Re: British Columbia Hydro and Power Authority (“BC Hydro”) Certificate of Public Convenience and Necessity for the Dawson Creek/Chetwynd Area Transmission Project, Project No. 3698640

REQUESTOR NAME: Commercial Energy Consumers Association of British Columbia (the "CEC")
IR ROUND NO: 3
TO: British Columbia Hydro & Power Authority ("BC Hydro")
DATE: November 18, 2011
PROJECT NO: 3698640
APPLICATION NAME: Certificate of Public Convenience and Necessity for the Dawson Creek/Chetwynd Area Transmission Project

Figure 5-1: System One Line Diagram - Alternative 1: SLS-BMT 230kV Transmission line

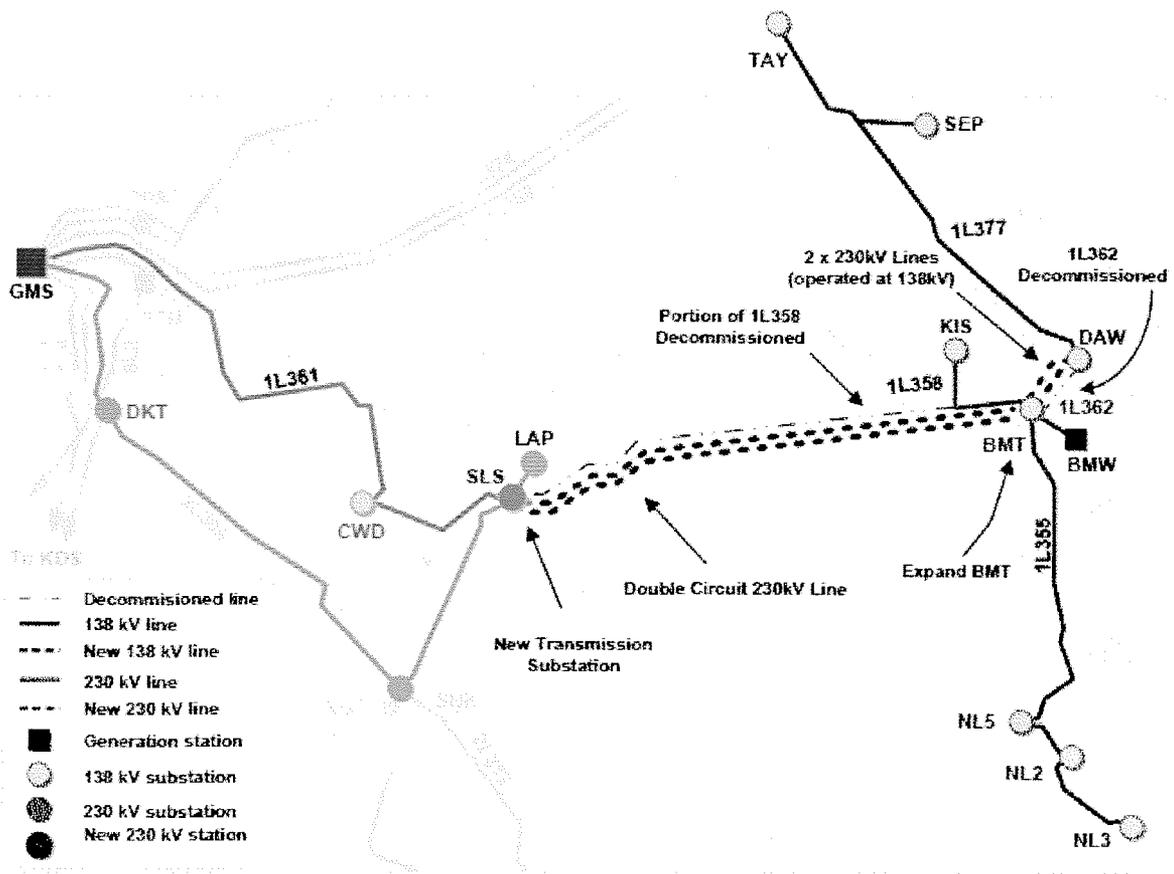
1.1. Under the base case assumptions please describe quantitatively the VAR requirements along 1L361, 2L309, 2L312, the new 230 KV circuit SLS to BMT, 1L358, the BMT to DAW double circuit, 1L355, 1L377 and the BMT wind farm interconnection.

- 1.2. Please confirm that the DCAT Project does not supply N-1 service to the Groundbirch, Bear Mountain or Dawson Creek loads until the 2nd stage project is delivered in 2016, because loss of the 2L309 line would result in voltage collapse.

- 1.3. Please describe how upon implementation of the DCAT Project the Chetwyn, Groundbirch, Dawson Creek area transmission system would be maintained and isolated from loss of the 2L309 line.

- 1.4. Please confirm that the DCAT Project, for N-1 planning purposes, would also be vulnerable to loss of the 2L312 line and please confirm that the same isolation requirements provided in answer to the above question would be applicable to the loss of 2L312.

- 1.5. For this Alternative 1, please describe the potential requirements for interconnecting Groundbirch loads, would this require a 230 KV to 138 KV or lower distribution voltage transformation and would this be expected to be supplied by the customer. Please provide a quantitative approximate cost for the customer interconnections.

Figure 5-2: System One Line Diagram - Alternative 2: SLS-BMT 138kV Transmission line

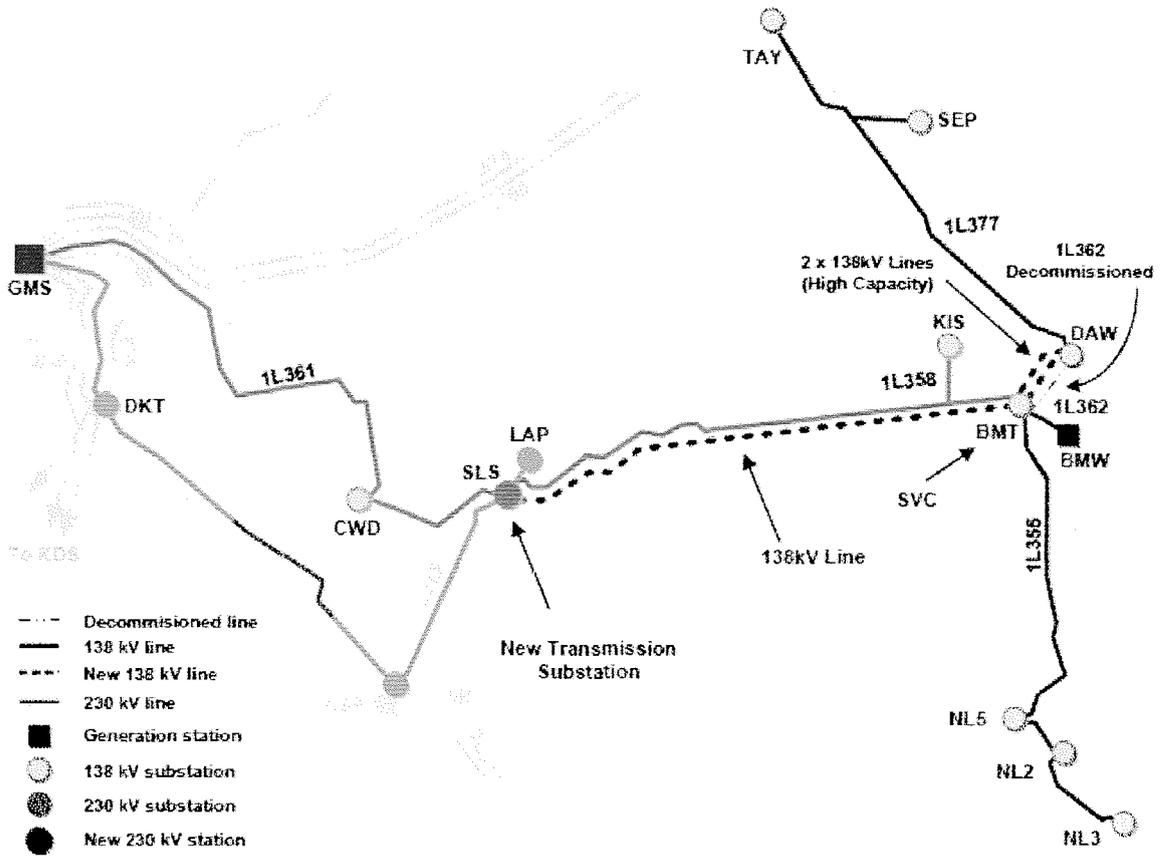
- 2.1. Under the base case assumptions for this Alternative 2 please describe quantitatively the VAR requirements along 1L361, 2L309, 2L312, the new 230 KV circuit SLS to BMT, 1L358, the BMT to DAW double circuit, 1L355, 1L377 and the BMT wind farm interconnection.

- 2.2. Please confirm that the DCAT Project does not supply N-1 service to the Groundbirch, Bear Mountain or Dawson Creek loads until the 2nd stage project is delivered in 2016, because loss of the 2L309 line would result in voltage collapse.

- 2.3. Please describe how upon implementation of the DCAT Project the Chetwyn, Groundbirch, Dawson Creek area transmission system would be maintained and isolated from loss of the 2L309 line.

- 2.4. Please confirm that the DCAT Project, for N-1 planning purposes, would also be vulnerable to loss of the 2L312 line and please confirm that the same isolation requirements provided in answer to the above question would be applicable to the loss of 2L312.

- 2.5. For this Alternative 2 please describe the potential requirements for interconnecting Groundbirch loads, would this require a 230 KV to 138 KV or lower distribution voltage transformation and would this be expected to be supplied by the customer. Please provide a quantitative approximate cost for the customer interconnections.

- 2.6. Please confirm that the SVC requirement at the BMT is to meet the VAR injection requirements in this alternative. Please describe how the VAR requirements differ between Alternative 1 and Alternative 2.

- 2.7. Please confirm that local generation, using synchronous generators, connected into the BMT station could provide the VAR injection requirements, being provided by the SVC.

- 2.8. Please describe quantitatively the amount of local generation that would be required, in this way, to provide the VAR injection requirements.
- 2.9. Please confirm that local generation connected into the BMT station would reduce the losses calculated for this Alternative 2.

- 2.10. Please provide the loss calculations for this Alternative 2 under various assumptions of the quantity of local generation from 75 MW to 125 MW assuming base load operation for the year.

- 2.11. Please confirm that local generation connected into the BMT station could provide capacity to the BC Hydro system, which would have its long-run marginal cost value to the electric system.

- 2.12. Please confirm that local generation of up to 125 MW connected to the BMT station could provide the transmission reliability for the Dawson Creek, Bear Mountain, Sundance Substation area but would still be vulnerable to loss of 2L309, for N-1 planning purposes.

- 2.13. Please quantitatively describe the local generation amounts, which BC Hydro would find acceptable for providing the N-1 reliability in the Dawson Creek, Bear Mountain, Sundance area, disregarding the loss of 2L309 requirements.

- 2.14. Please describe quantitatively the loads on SNK, the 2L309 line, the 2L312 line and the 2L313 line, which would need to be met in the event of loss of the 2L309 line.
- 2.15. Please confirm that if local generation were provided to SNK in the amount of the loading on 2L309 this would be sufficient along with adequate local generation connected to BMT to provide the N-1 reliability requirements, which would be met by the DCAT Project Alternative 1 and a second stage option for additional 230 KV transmission resources.
- 2.16. Please describe qualitatively and quantitatively any other system planning requirements that would have to be met by a local generation alternative by 2016 to provide N-1 reliable transmission to the Groundbirch, Bear Mountain, Dawson Creek loads anticipated in the base case load forecast.

Figure 7 - Dawson Creek and Groundbirch area Load Forecast (MW)

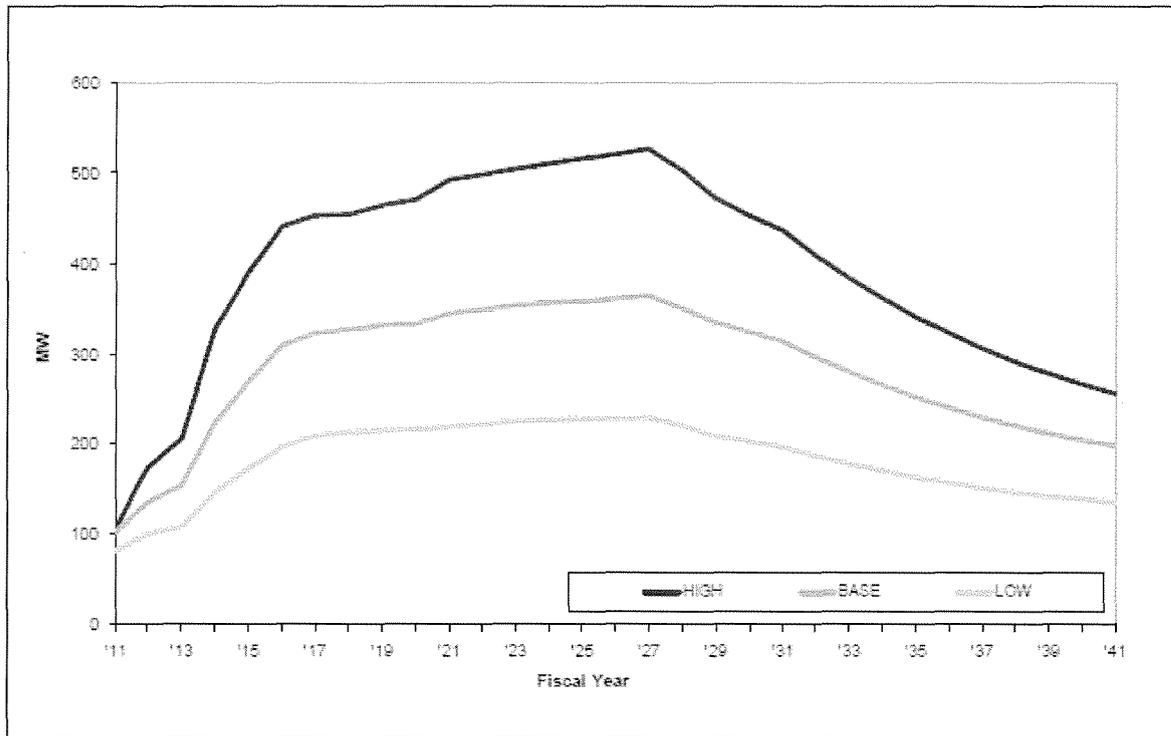
- 5.1. Given the significant peakiness of the load forecast over time please explain what, if any, plans does BC have to reduce the peak requirement in order to minimize the transmission investment requirements.
- 5.2. When would BC Hydro make commitments to its second stage transmission design and investments in order to deliver those by 2016?
- 5.3. When BC Hydro is committing to its second stage investment following the initial DCAT Project will BC Hydro know whether or not it will have a high likelihood of a high, low or base case forecast load or will there still be considerable uncertainty because of the unknown variables?
